Resolution of the Direct Containment Heating Issue for All Westinghouse Plants With Large Dry Containments or Subatmospheric Containments

Resolution of the Direct Containment Heating Issue for All Westinghouse Plants With Large Dry Containments or Subatmospheric Containments

Appendix A	Peer Review of NUREG/CR-6338.....	A-1
Appendix B	Melt Mass/Composition Distributions.....	B-1
Appendix C	Plant Geometry.....	C-1
Appendix D	Catalog of IPE Containment Fragility Curves for Operating Pressurized Water Reactors (PWRs).....	D-1

Figure D.1 Comparison of steel containment fragility curves (non-Ice Condenser type).

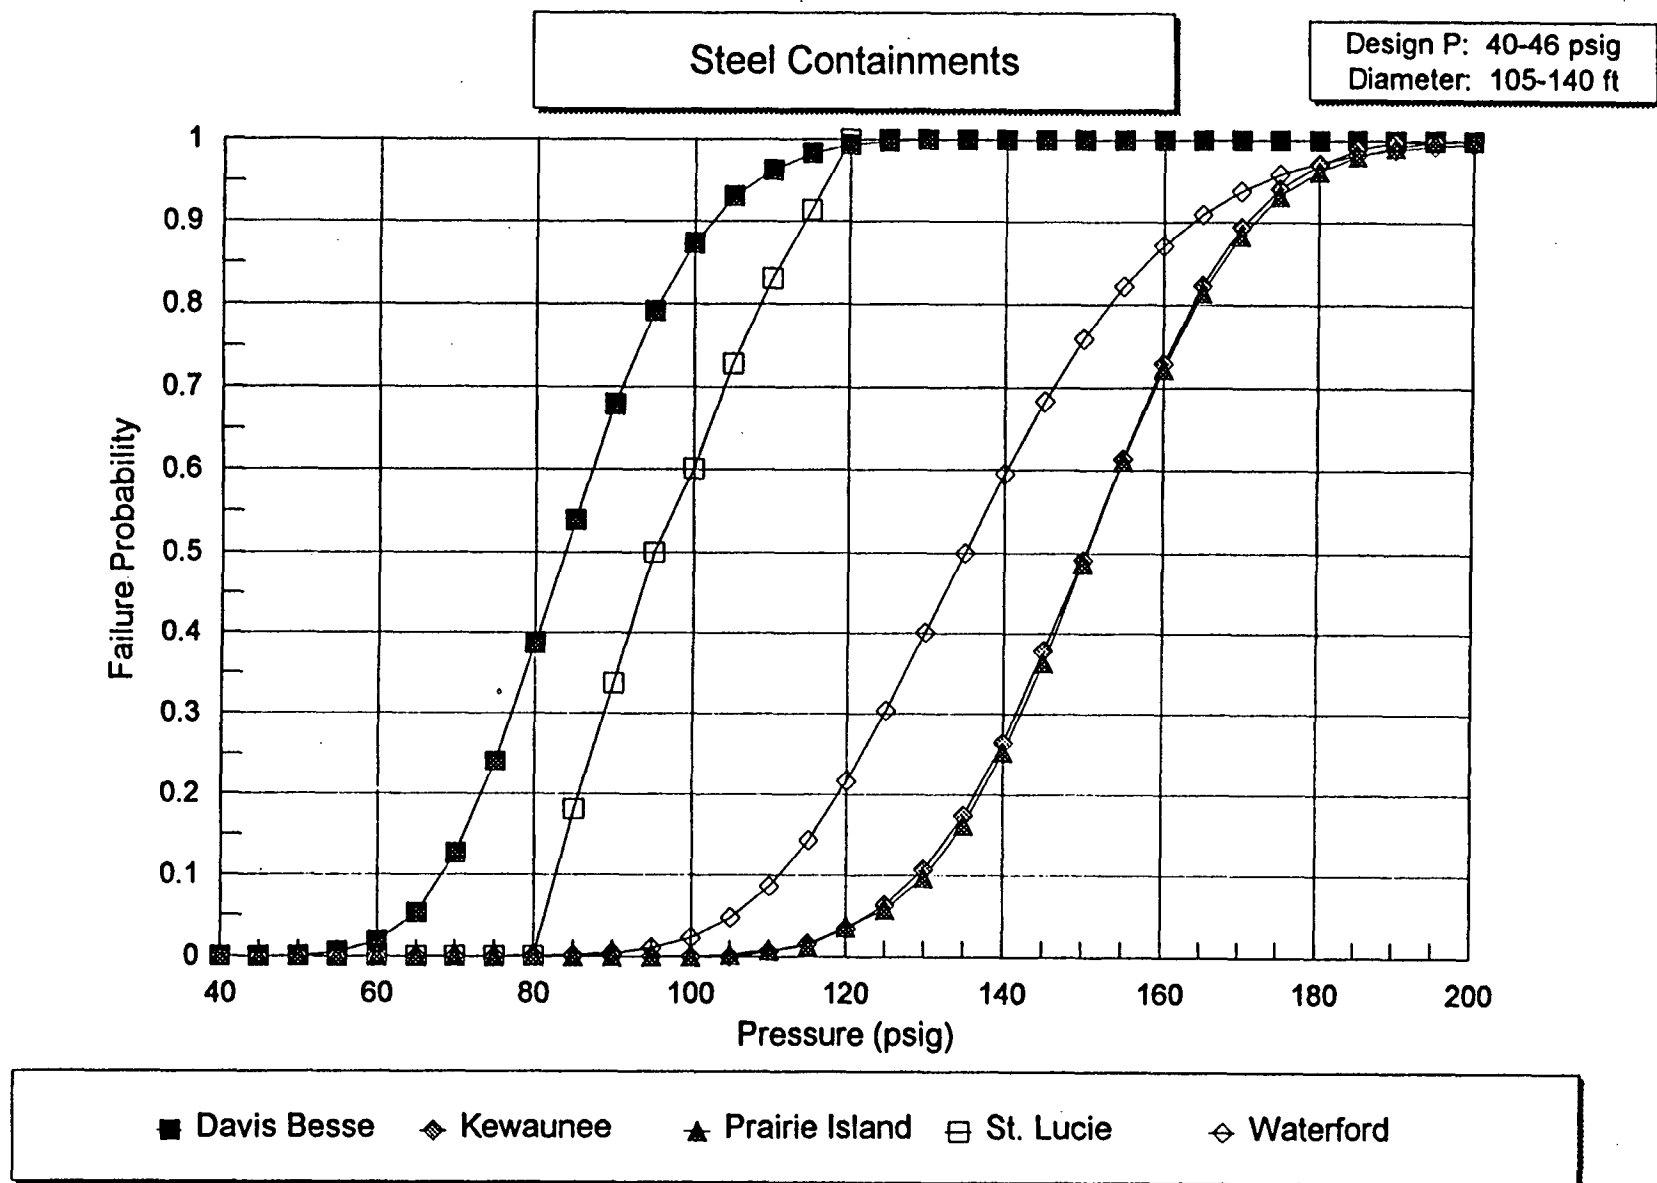
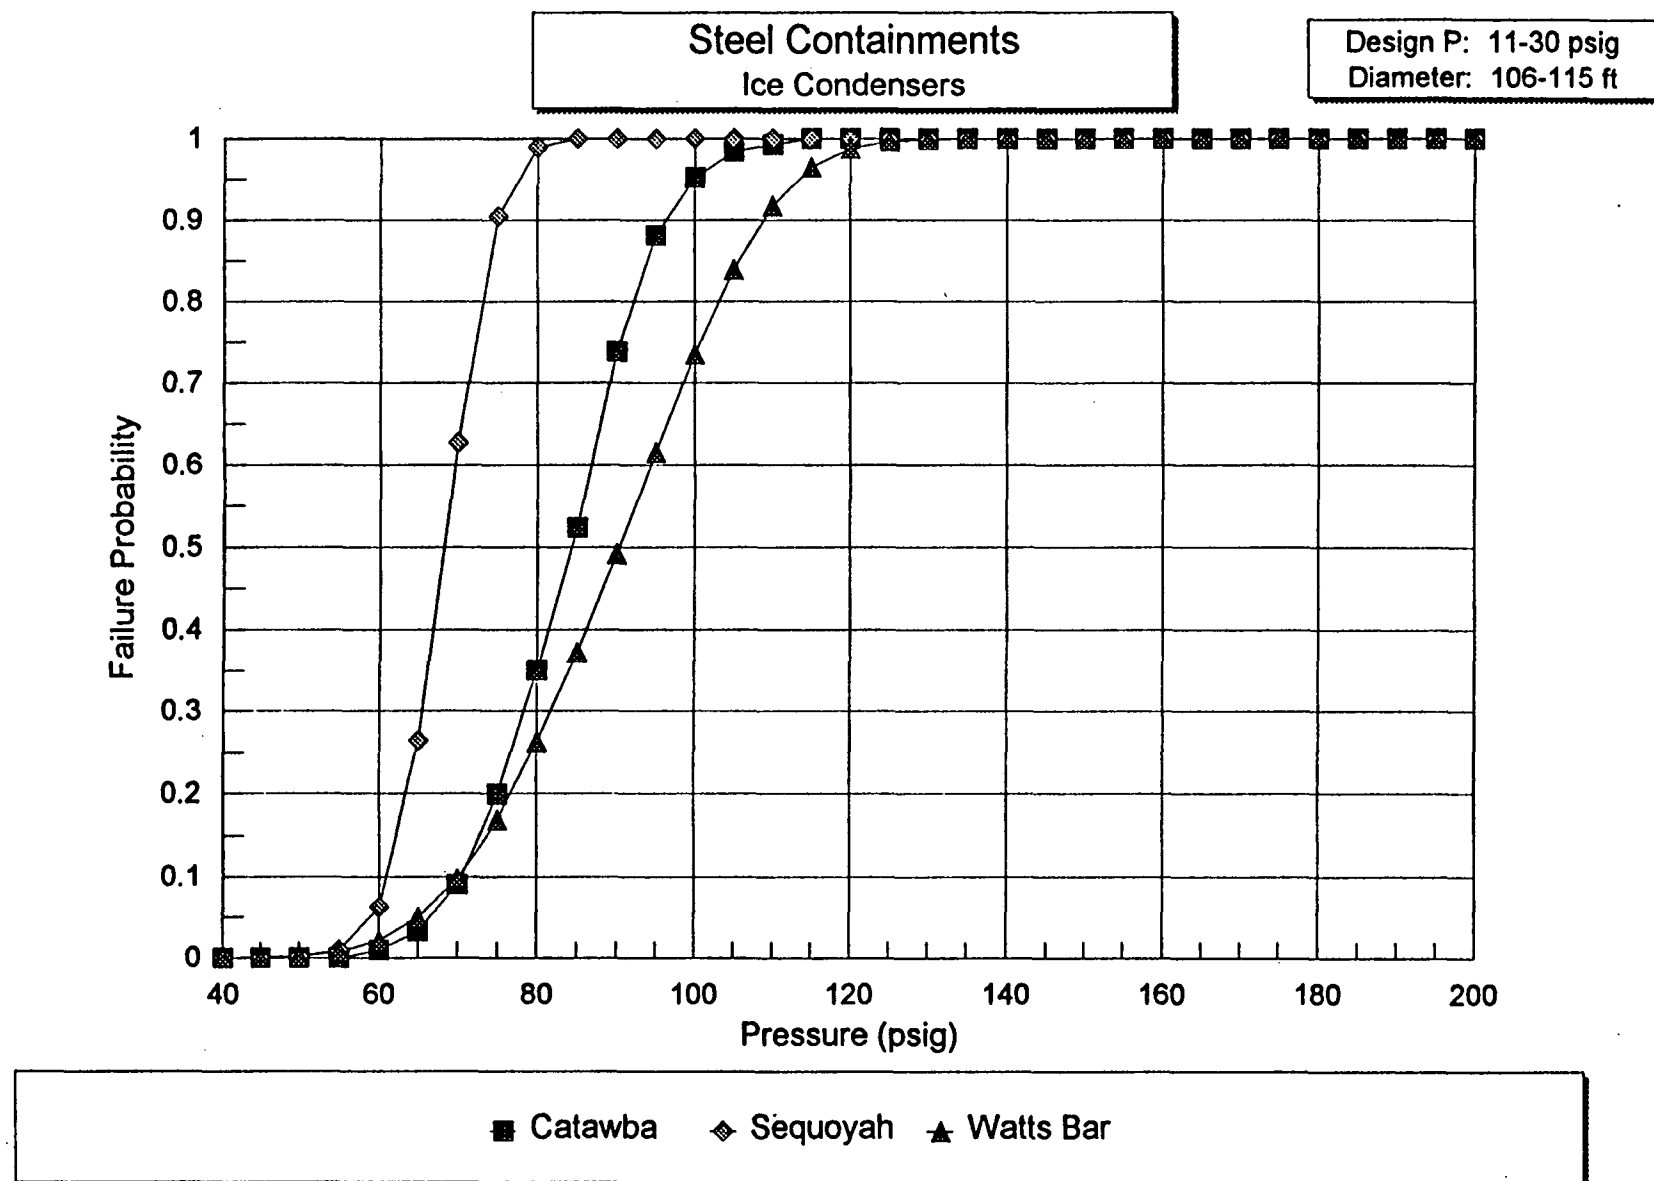
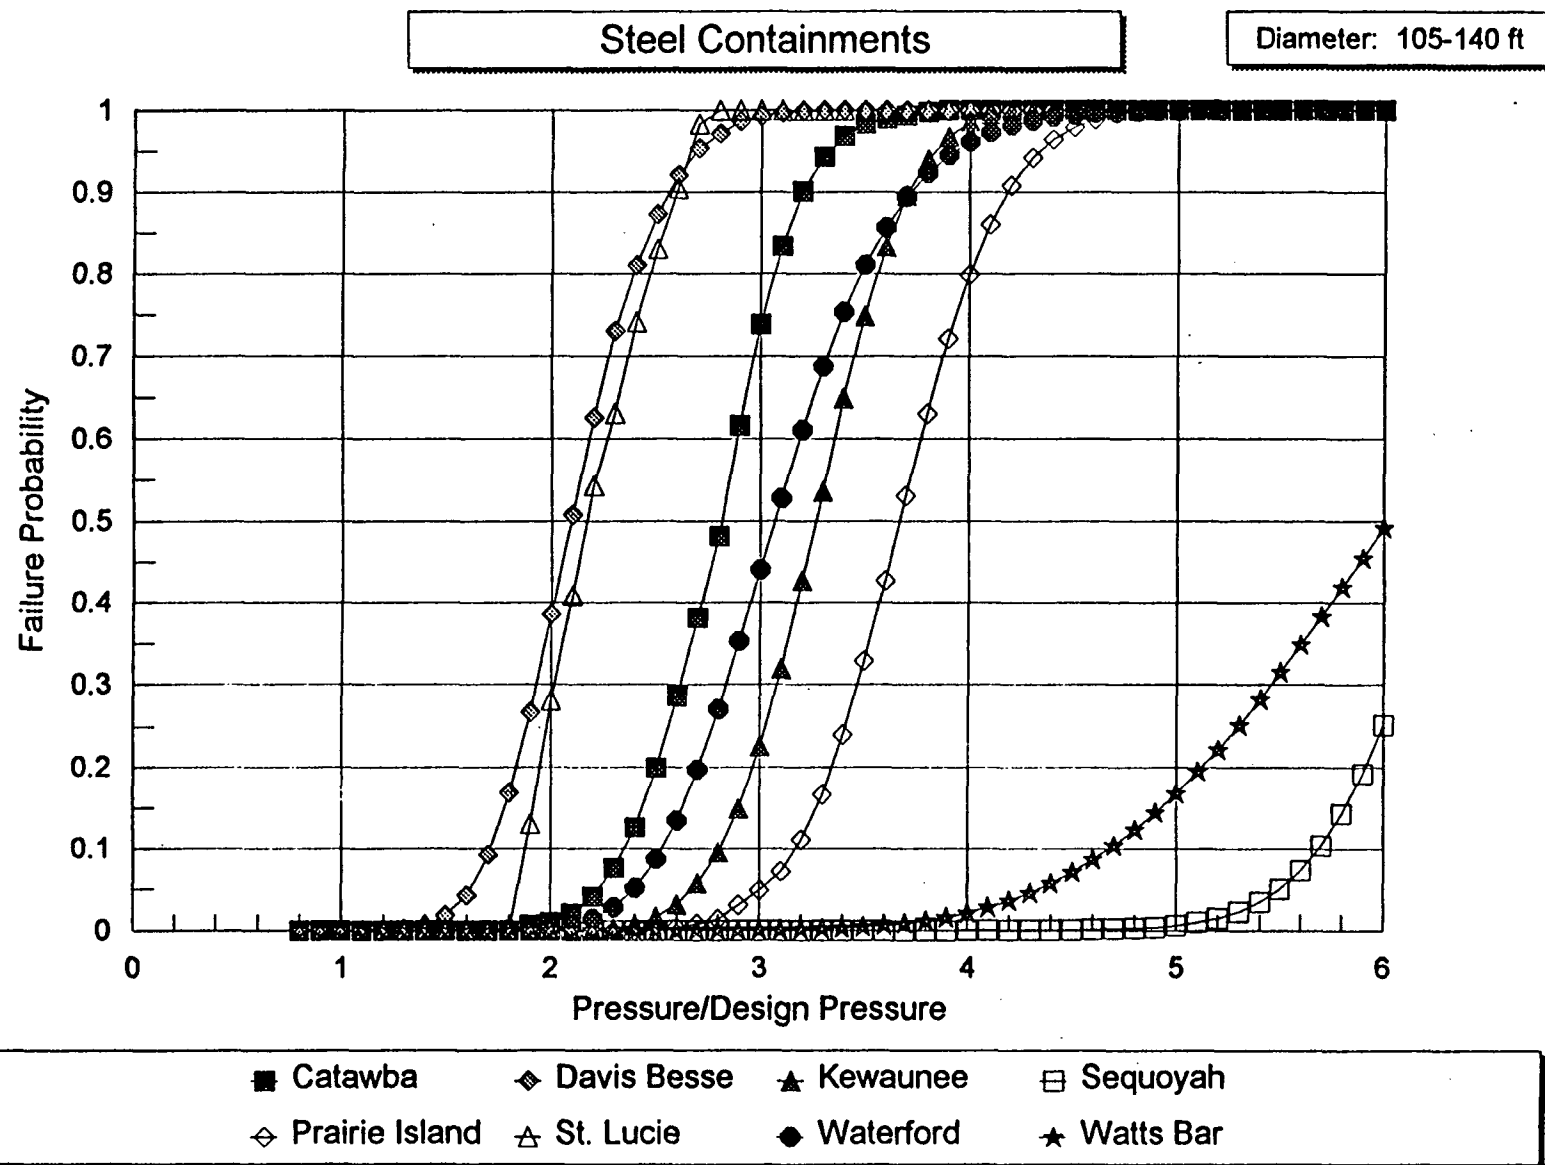
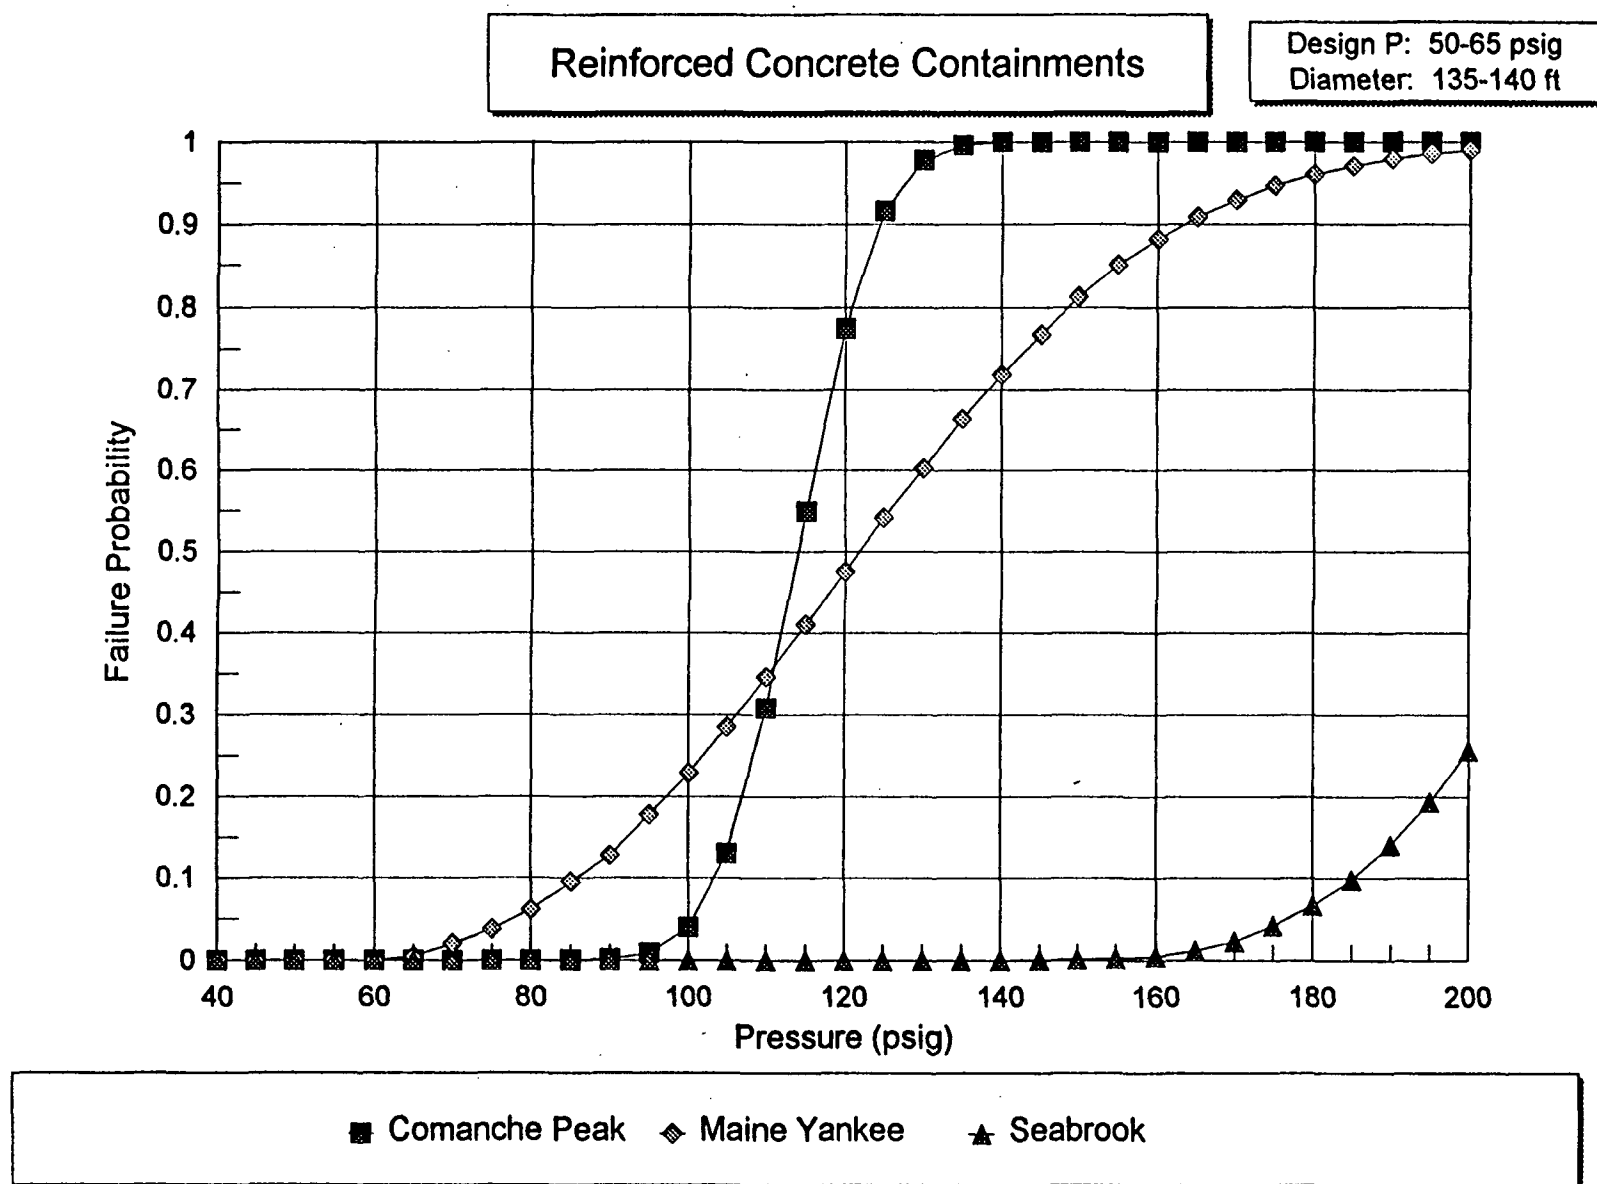
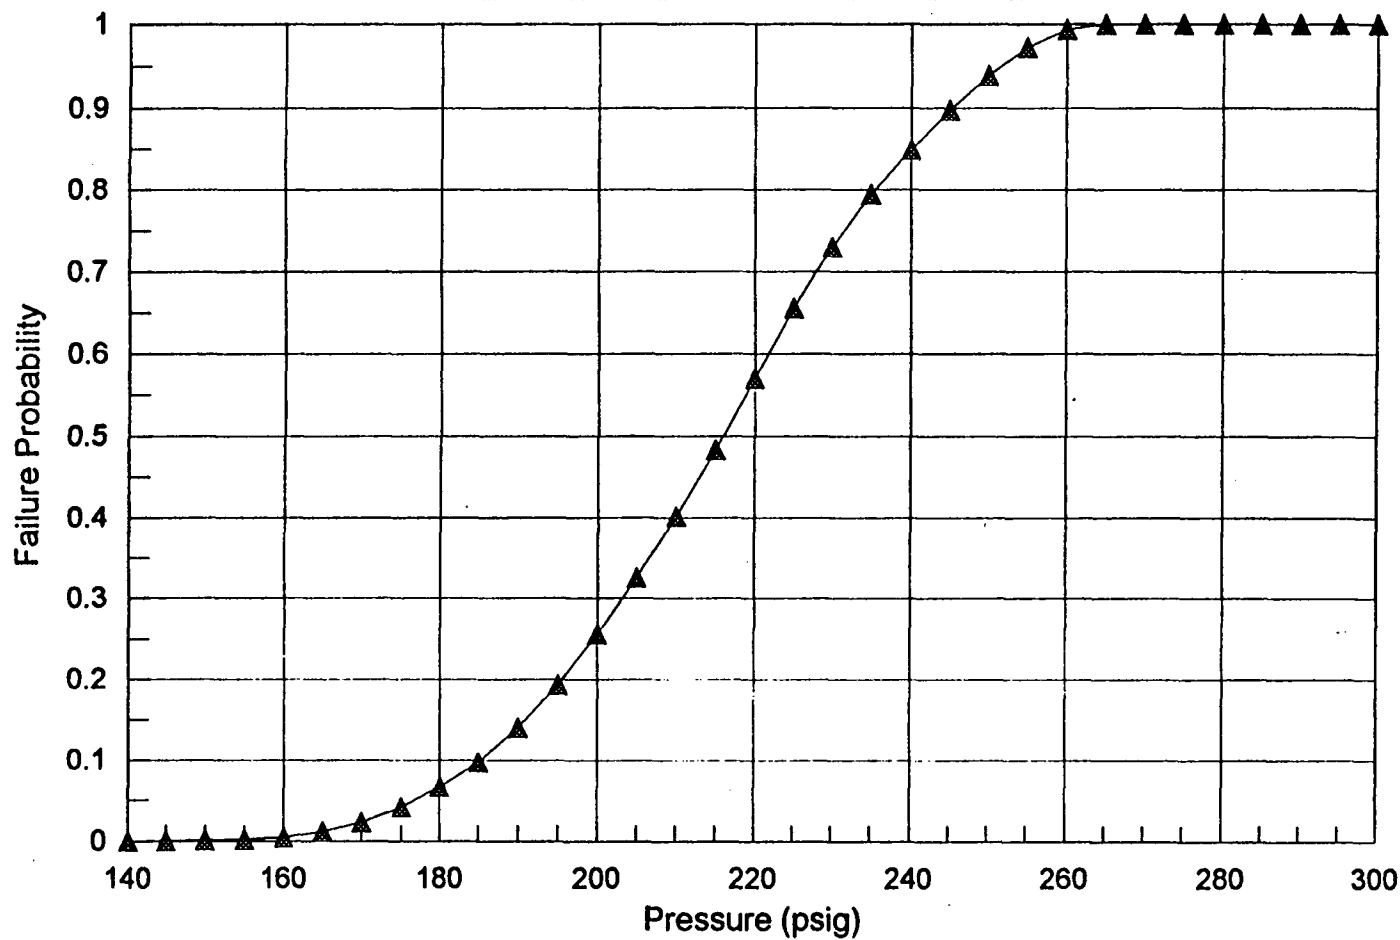
Page D-15; Section D.4.2: Some fragility curves reported and compared in this section are not about the plants within the scope of this study. For example, fragility curves of some ice condenser, CE and B&W plants are presented. Also, I fail to see the main purpose and significance of this comparison effort in the CCFP calculations. For example, Figures D.1 through D.17 seem to have no or small relevance to this analysis.
